30-045-05447 CENTRAL BISTI UNIT #071

DJR OPERATING, LLC

Plug and Abandonment Procedure
for
DJR Operating, LLC
Central Bisti Unit 71
API # 30-045-05447
SE/SE, Unit P, Sec. 9, T25N, R12W
San Juan County, NM

Re: Permanent Abandonment
Well: Central Bisti Unit 71

Proposed PXA Wellbore Diagram
DJR Operating, LLC
Central Bisti Unit 71

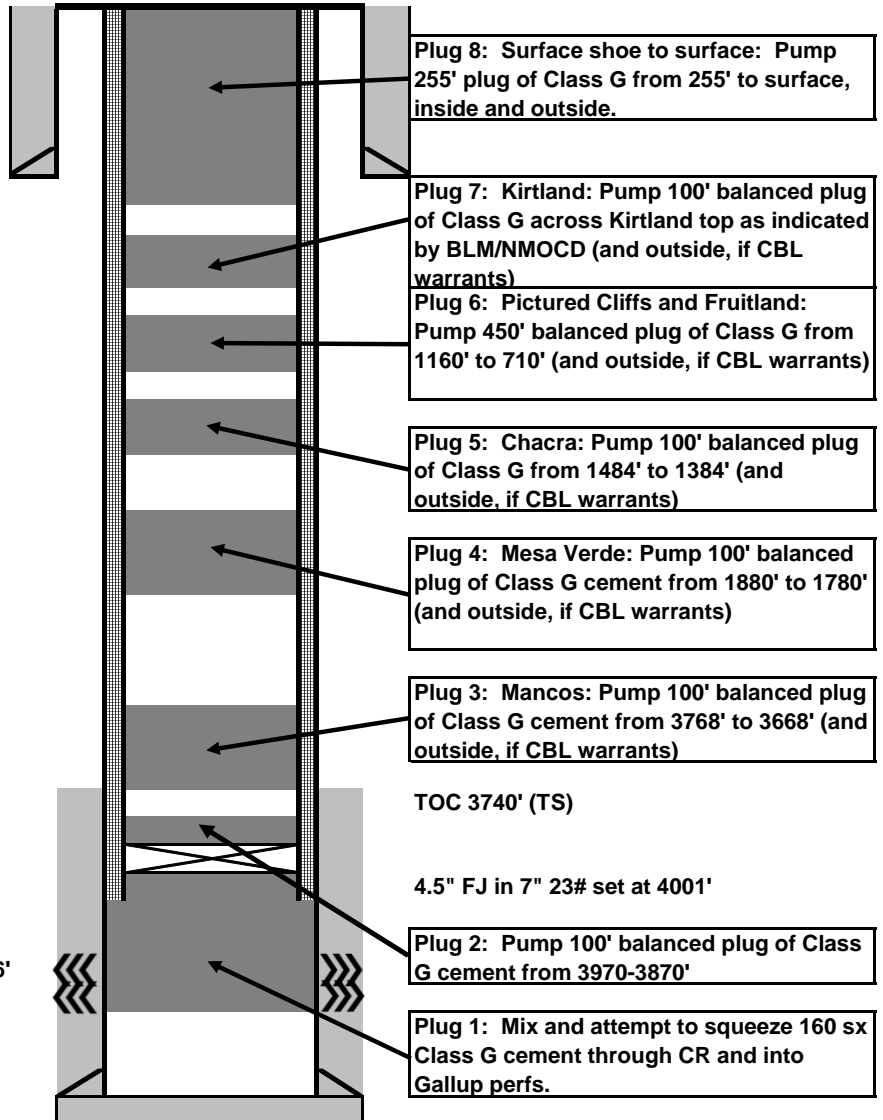
- Notify NMOCD 24 Hours prior to commencing activities
- In addition to the BLM approved plugs:
- Ensure coverage 4705'-4605'. OCD Gallup pick @ 4655'.
- CBL Required.

-Please note that while the depths for most formations differ only slightly between the Operator's picks and the BLM geologist's picks, the BLM Geologist interprets the La Ventana Ss Tongue/Cliff House Ss as a continuous sandy interval containing both these units.

-The Ojo Alamo formation top is above ground level and the formation is protected adequately by the proposed plugging procedure.

-The Gallup identified is the actual Gallup formation, not a sand body within the Mancos.
